OCP NIC 3.0 Design Specification

Version [0.840-83](#)

Author: OCP Server Workgroup, OCP NIC subgroup

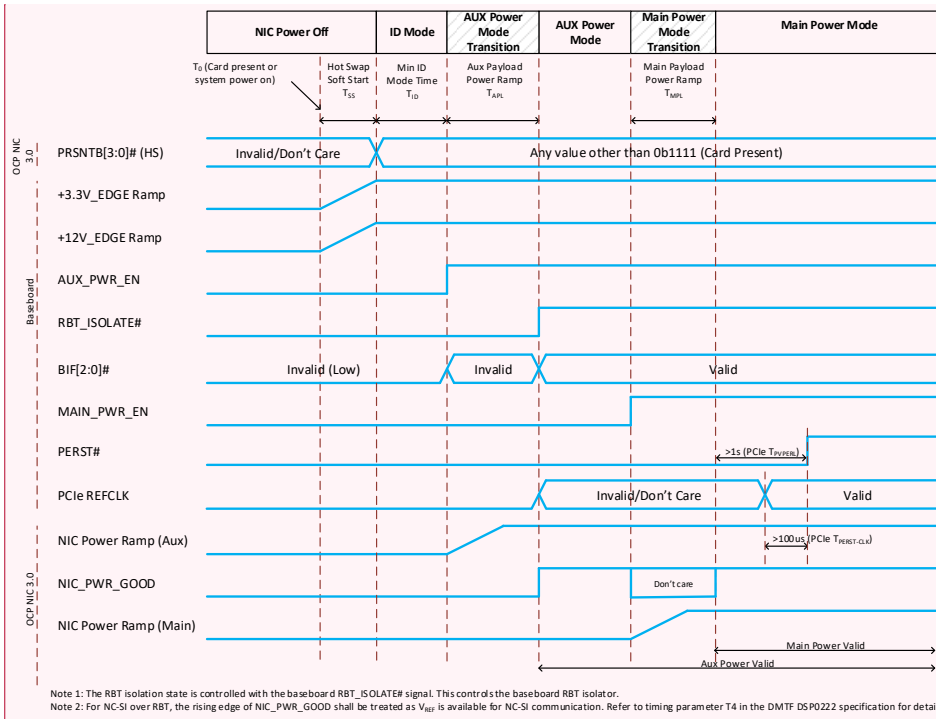
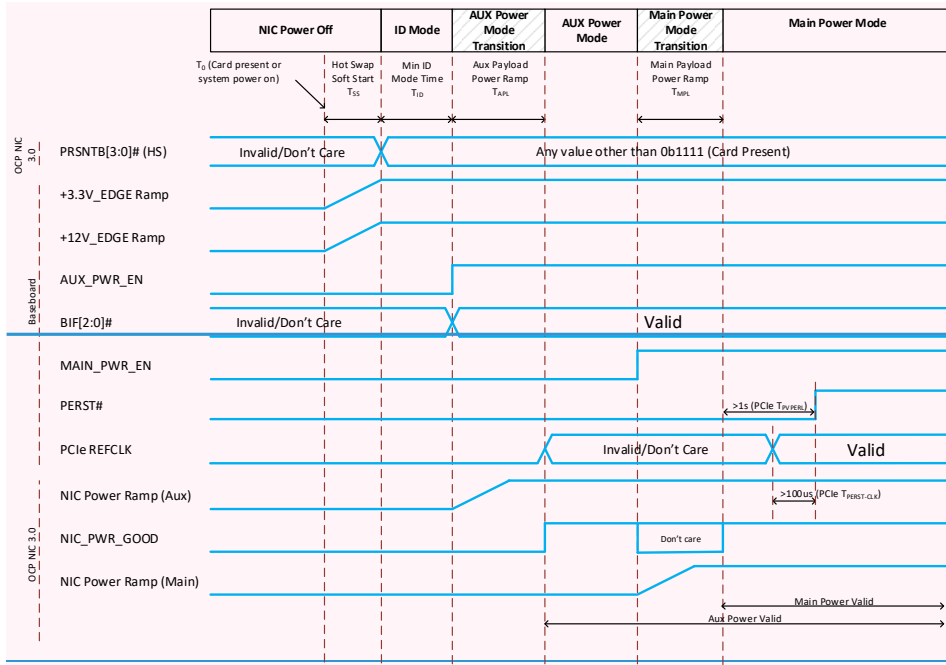
3) Propose to add NC-SI start-up timing from DMTF DSP0222 spec of "T4 – Network Controller Power up ready interval – 2s max" from NIC_PWR_GOOD to RBT ready to power-up sequence in Fig 94. RBT can also be shown to be isolated prior to this timing.

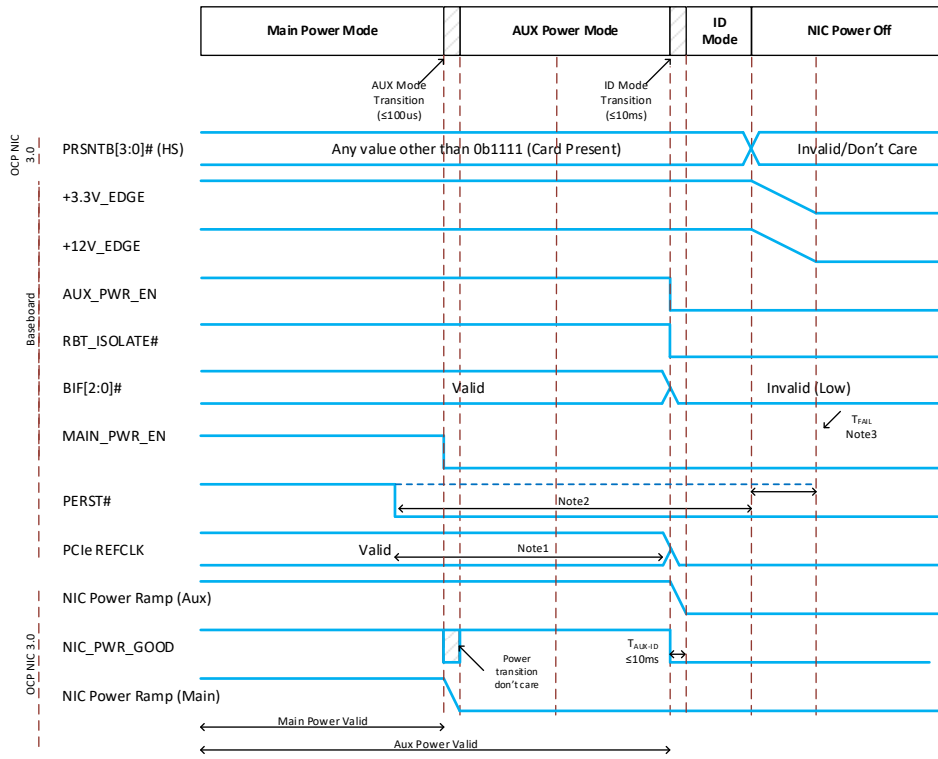
1)For dynamic bifurcation use case where 3_3V_EDGE/12V_EDGE are still up, need minimum time duration for AUX_PWR_EN and MAIN_PWR_EN to stay down for NIC cards to completely discharge downstream VRs to prevent unintended side effect if the system come back up too fast.

2)Taux-ID <=100uS in diagram. Table 37 shows Taux-ID = 10ms?
